Cooperative Hydrology Study (COHYST) Independent Peer Review Findings Final Report

October 15, 2005

The purpose of the Independent Peer Review was to evaluate the credibility of the model reports, the underlying model datasets, and supporting data and information by providing answers to the following questions:

Figure
 55

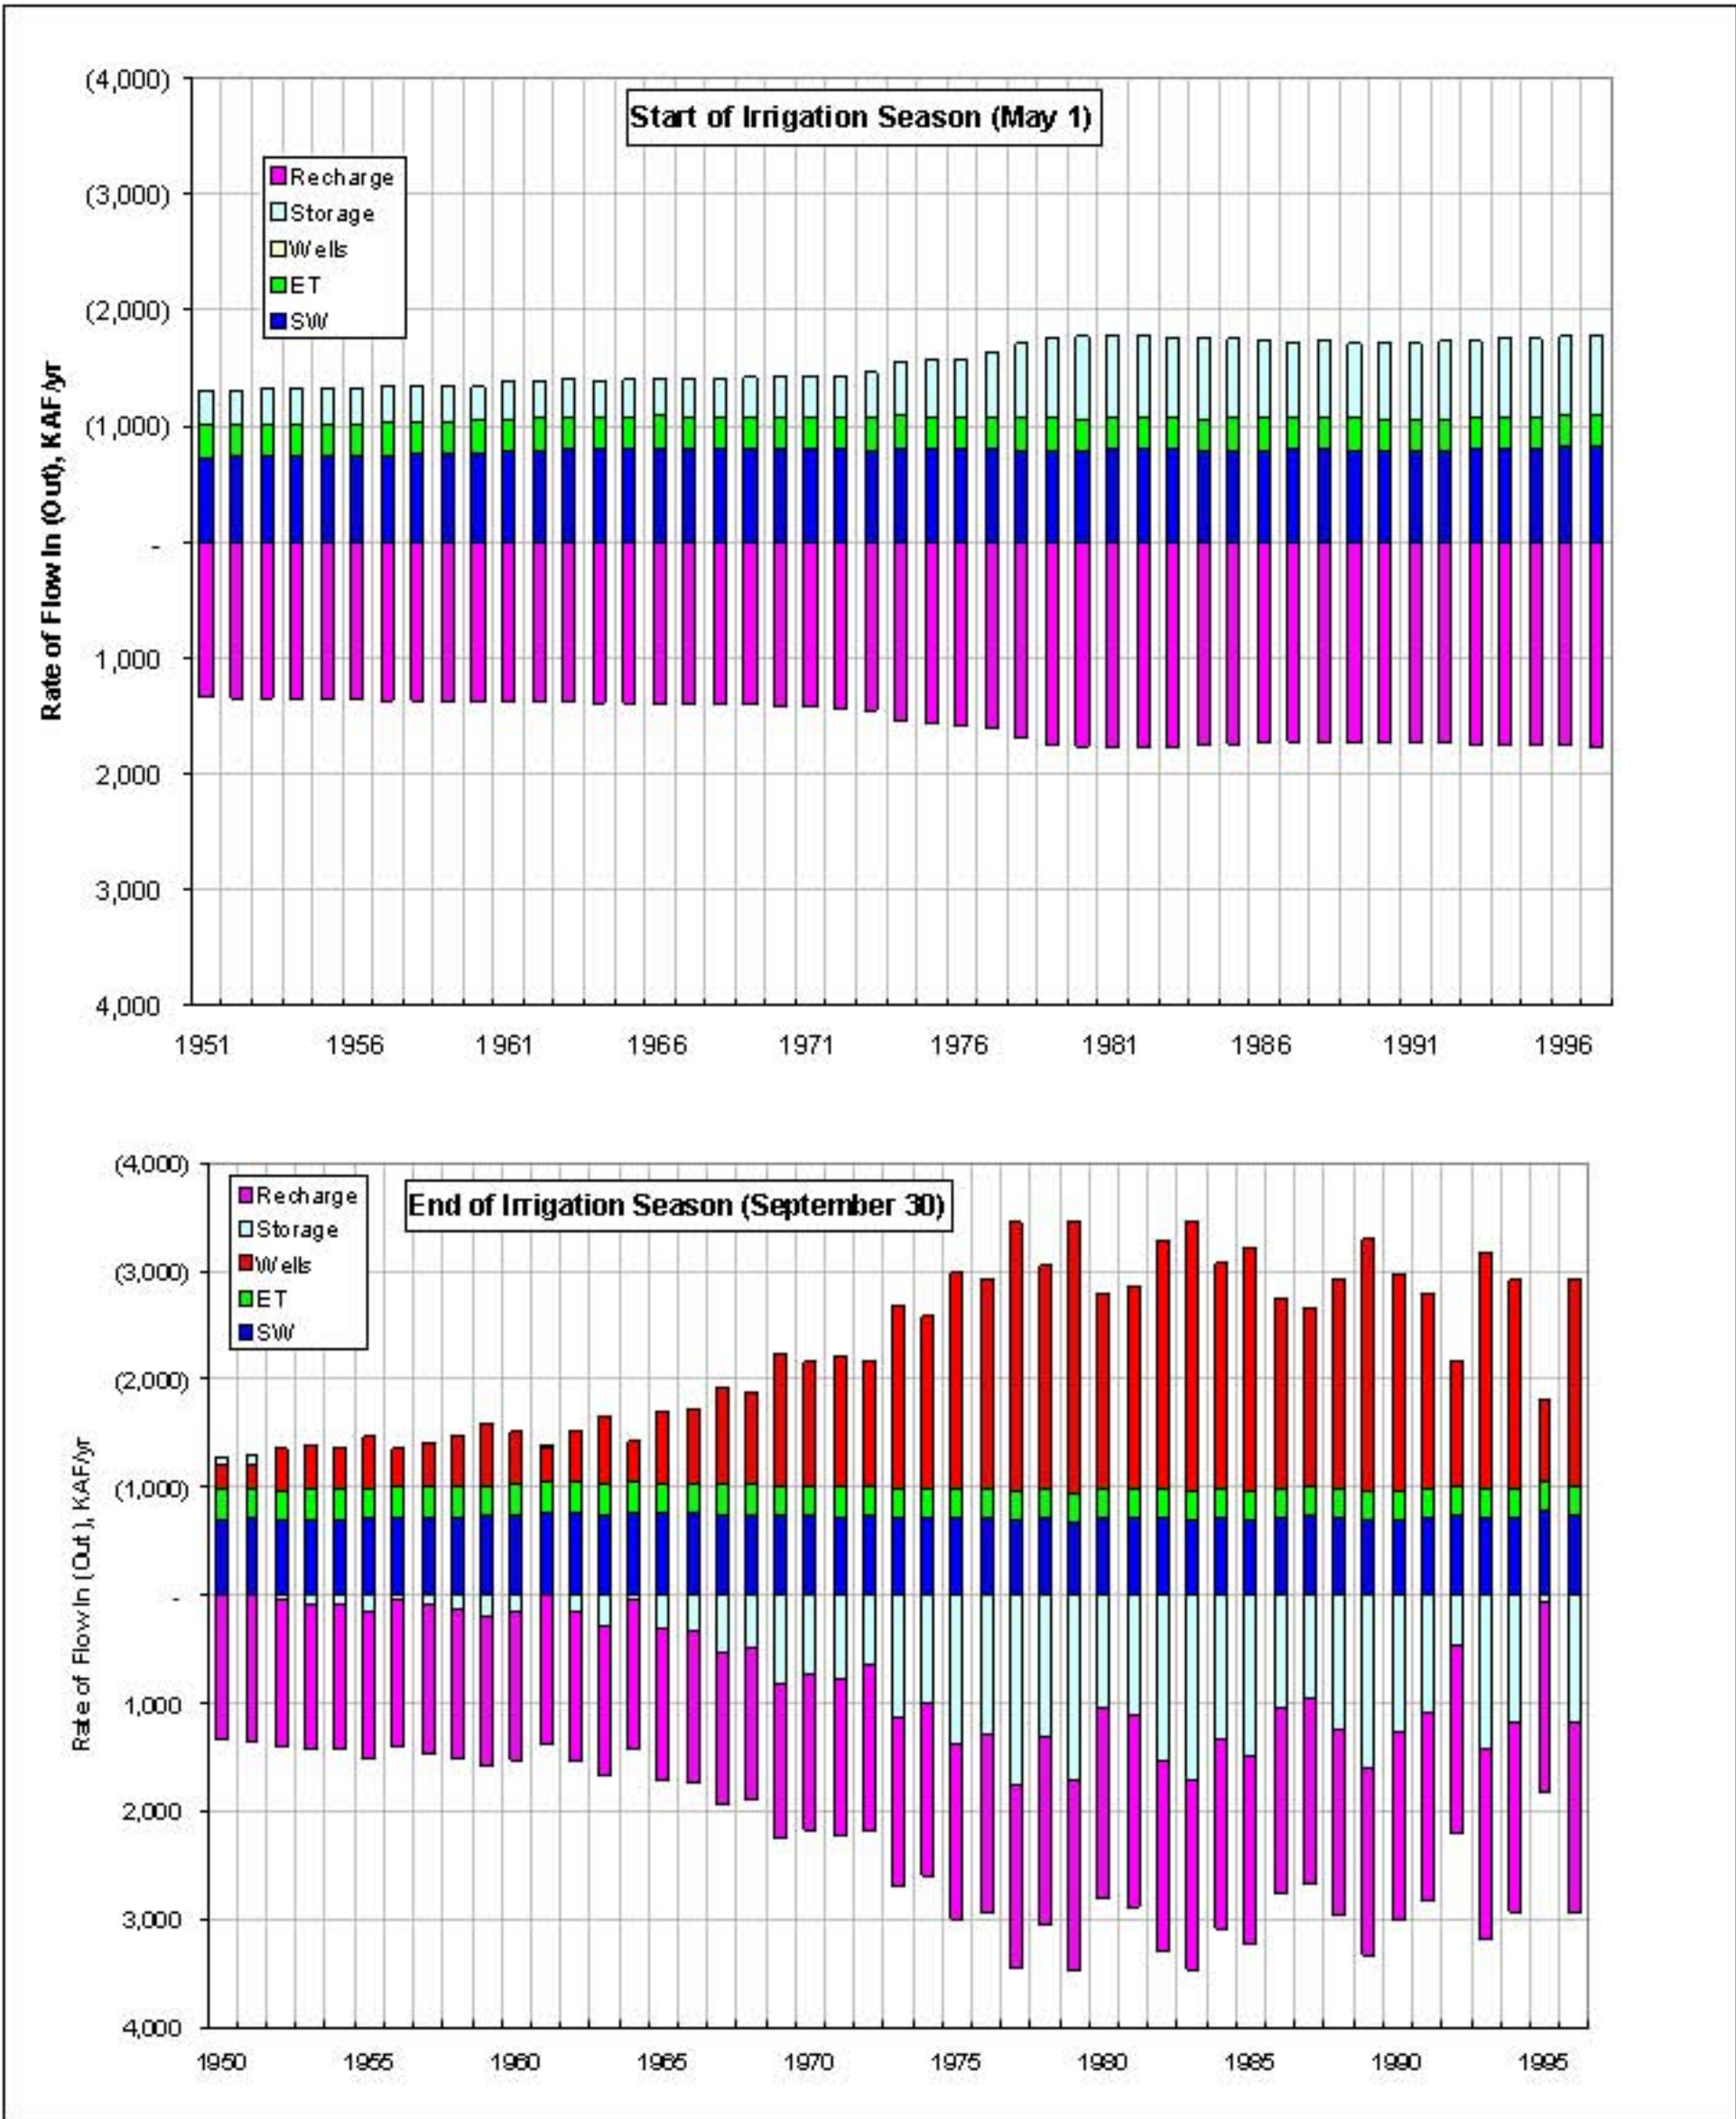
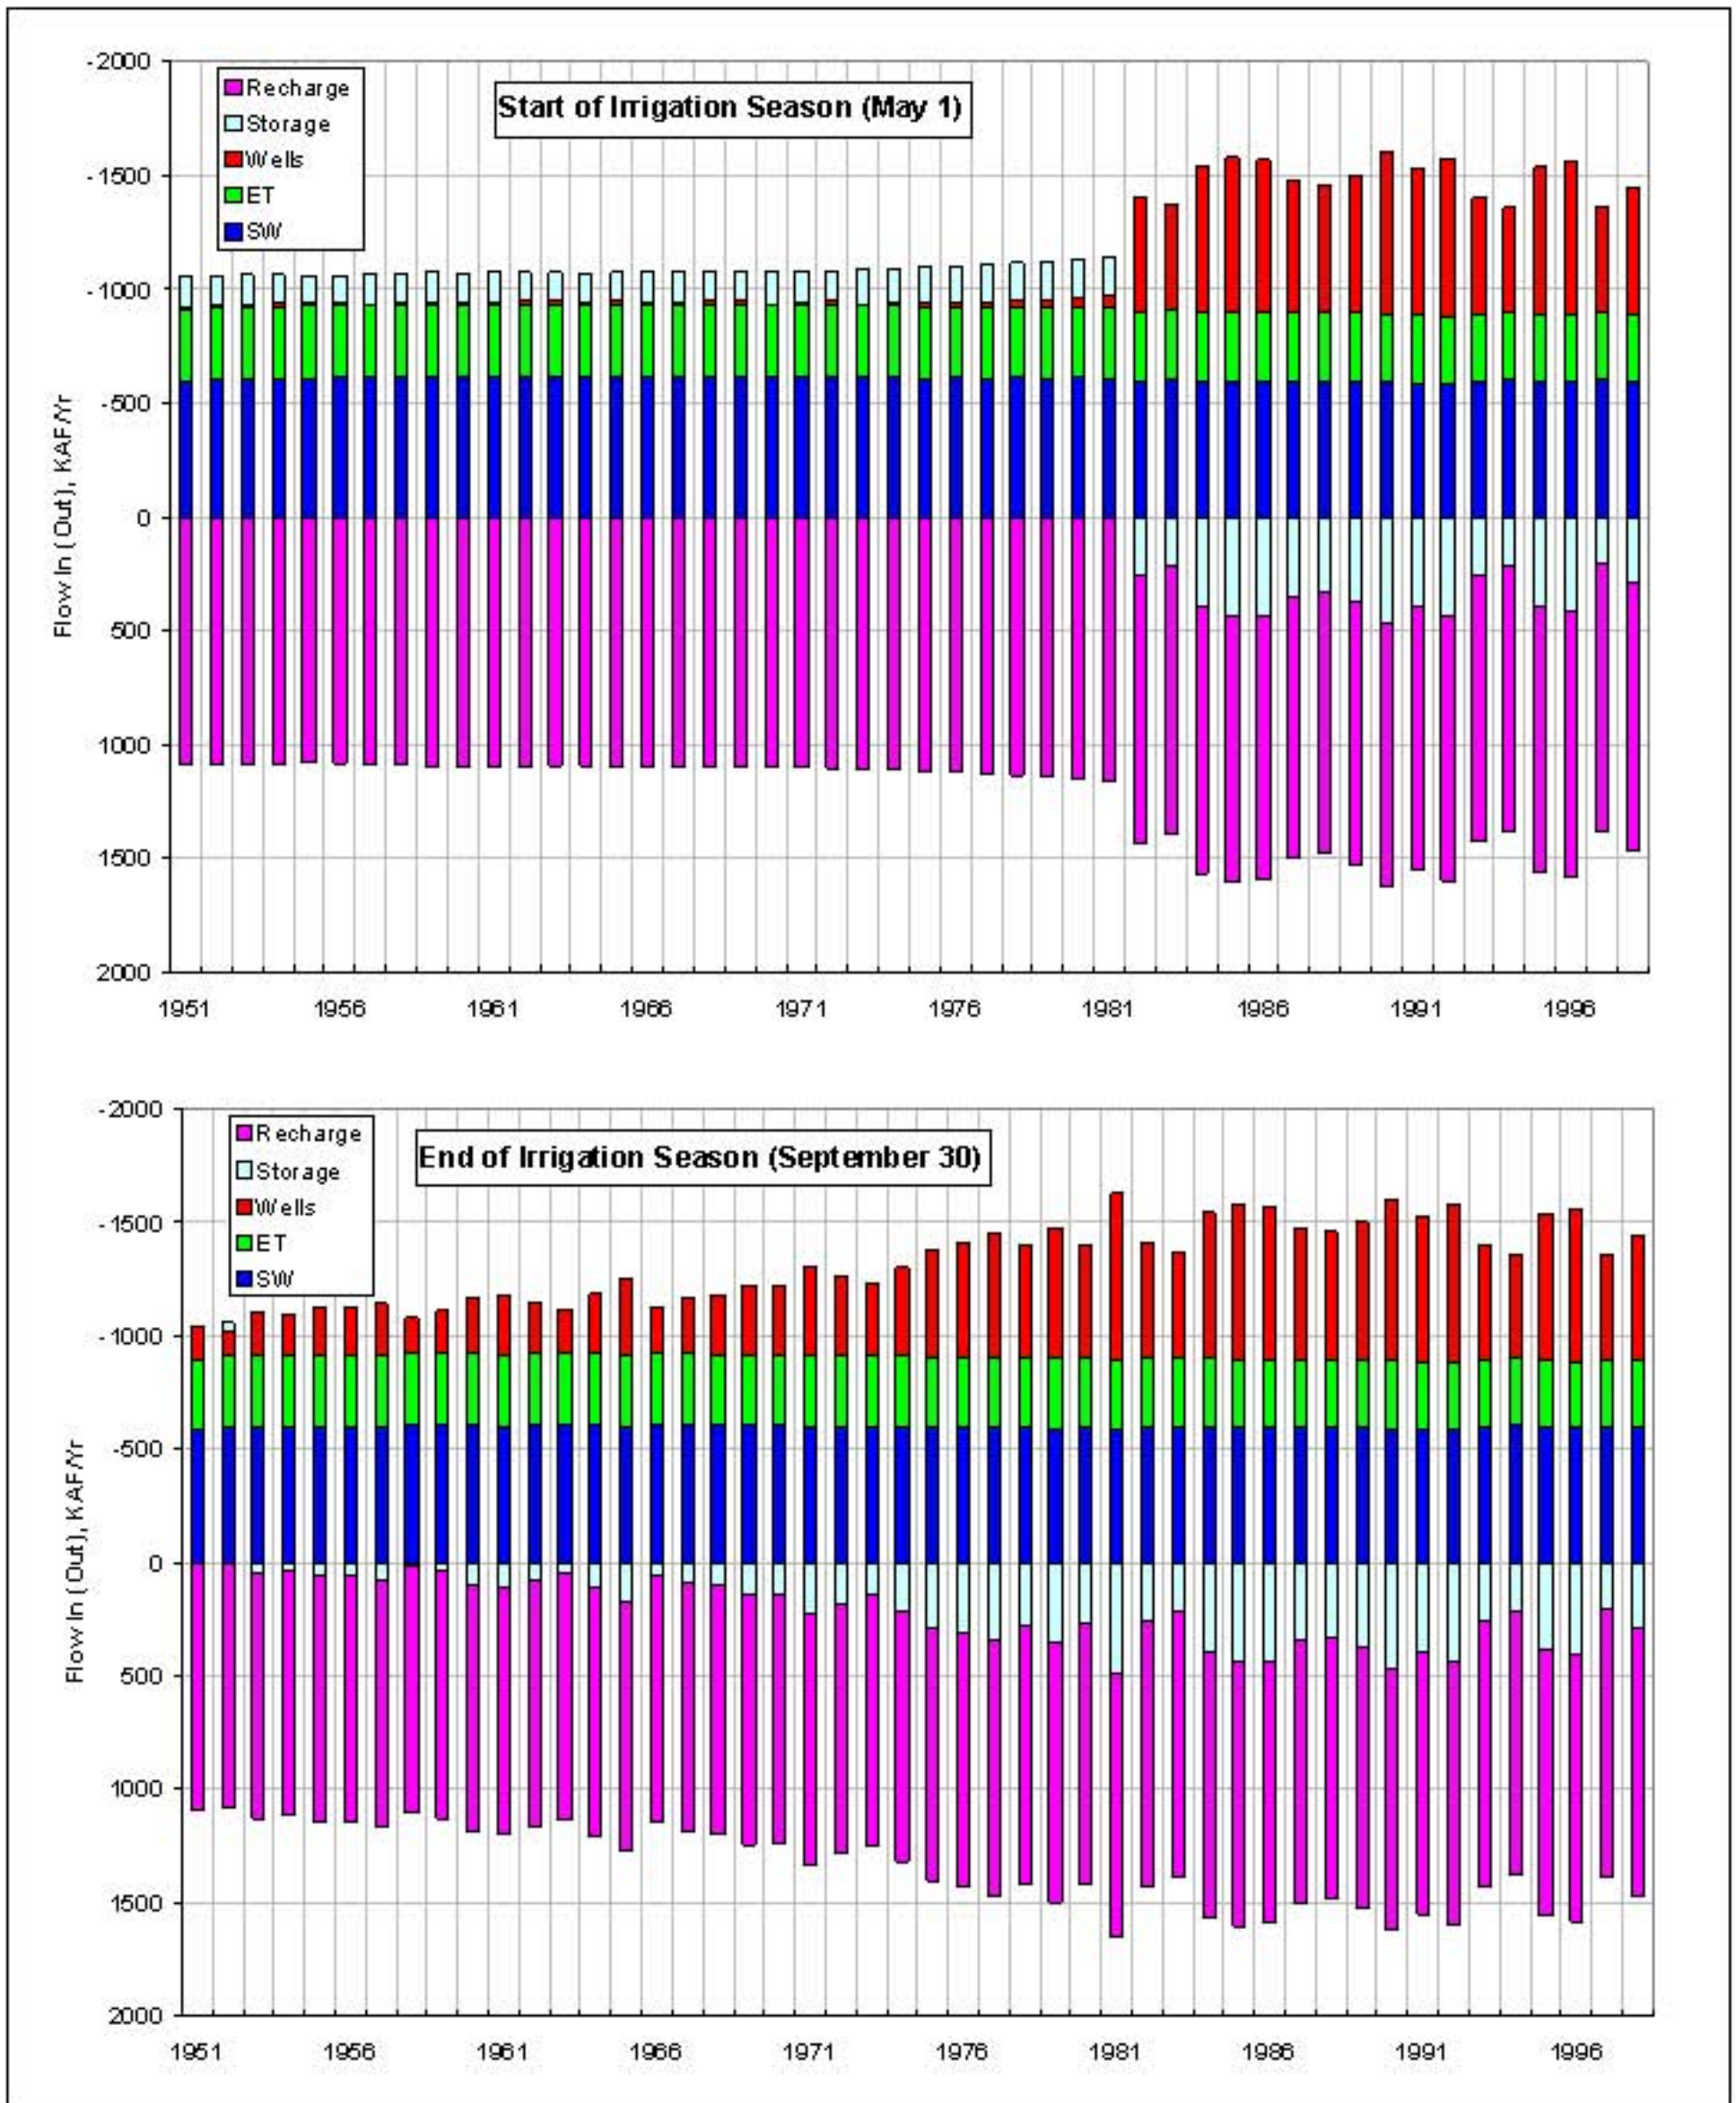
Review of the model datasets shows that ET was simulated during the entire year, and the analysis of water balance components shown in Figures 55 through 57 included for this report show that simulated ET during the winter months was significant. Because this is not realistic, reliability of the models to assess scenarios in which ET is important has not been established and this limitation needs to be addressed to demonstrate the reliability of the models.
